Amendments to the Drawings:

LUMINAIRE
INVENTOR: BARRY WHITE, et al.
SN: 10/616,743; DOCKET NO.: 0331
ATTY: DONALD E. HASSE; PHONE: (513) 229-0383

FIG. 1

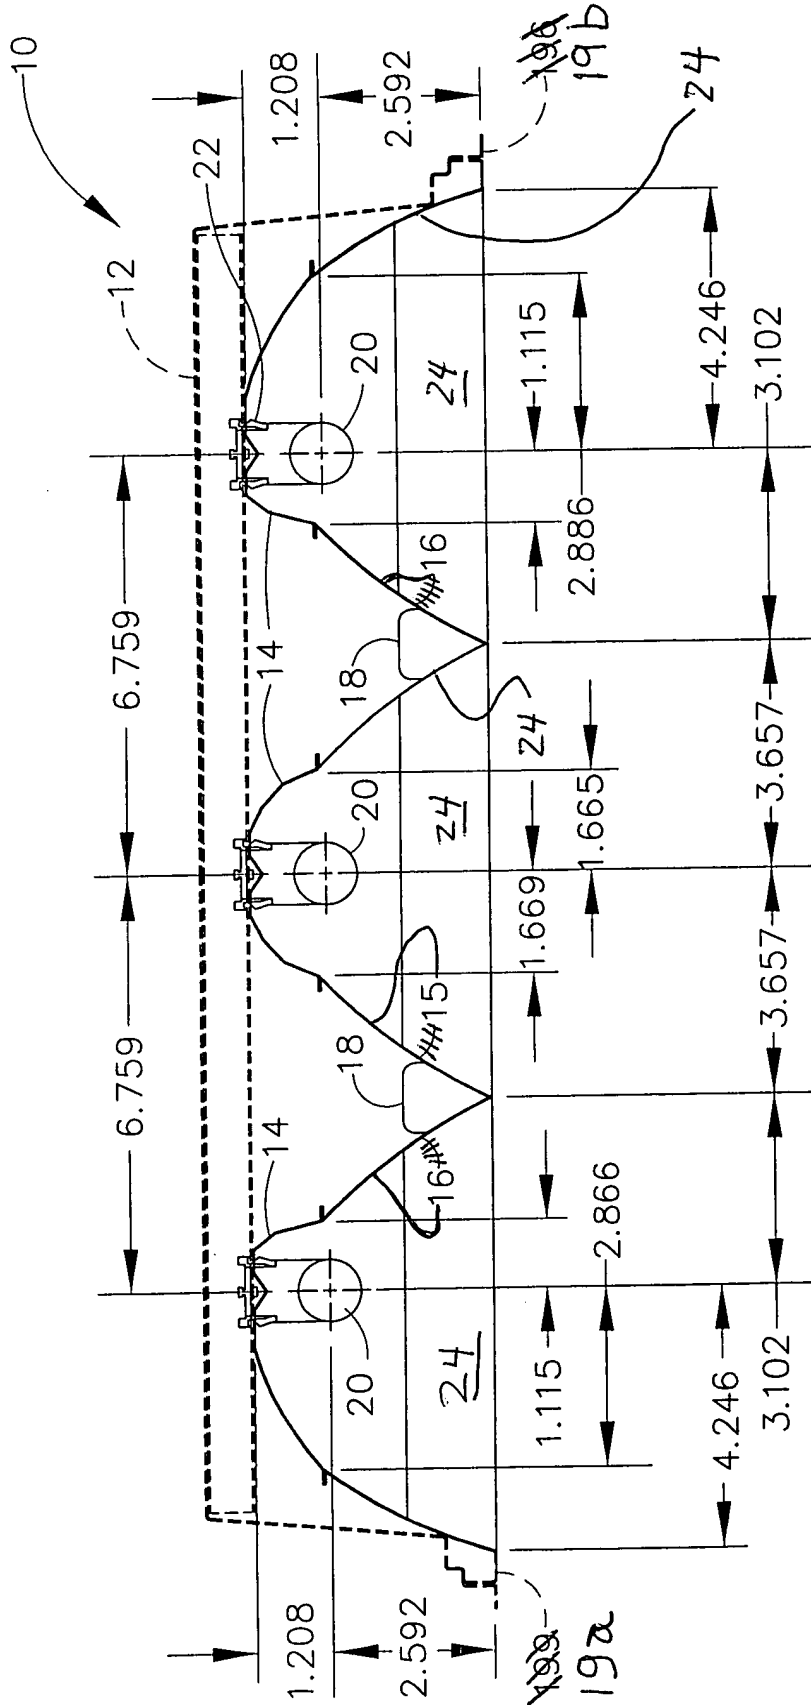
In the drawings, the Examiner has objected to the references 19a and 19b as designating both "edge" and "outer edge" (at page 5, lines 12 and 23). To traverse this objection, Applicants have amended the specification at paragraph [0020] to change "edge" to "outer edge".

Applicants are submitting replacement drawing sheets 1 and 5. Drawing sheet 1 for Figure 1 has been amended to correct the reference number "199" to --19a-- and "196" to --19b--.

Support for these amendments is found at page 5, lines 12 and 23 of the specification as filed. Figure 1 has also been amended to adjust the lead lines for reflectors 15 and 16, and to add reference number 24 with lead lines to the louvers. Support is found in FIG. 5 and in Claim 14 as originally filed.

FIG. 5

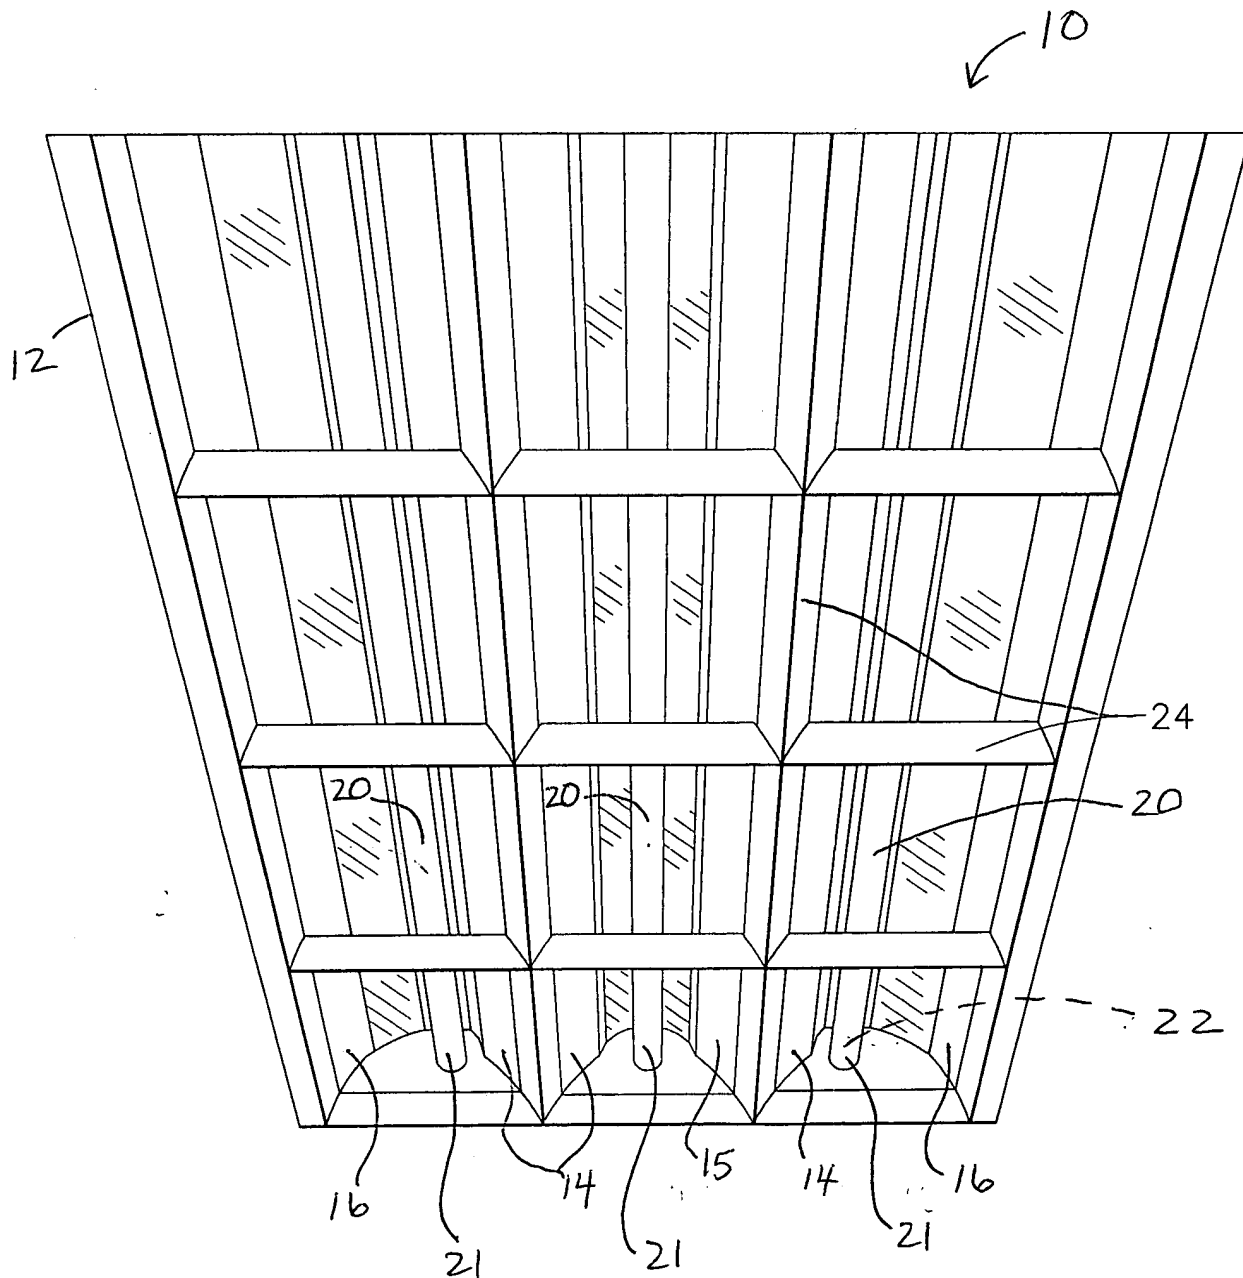
Drawing sheet 5 for FIG. 5 has added reference numbers and lead lines for the following elements: luminaire 10, housing 12, reflector 14, symmetric reflector 15, asymmetric reflector 16, tube 20, tube ends 21, tube end 21, and socket 22, and an additional lead line from reference number 24. Support can be found in Figure 1, and Claim 5 as originally filed.
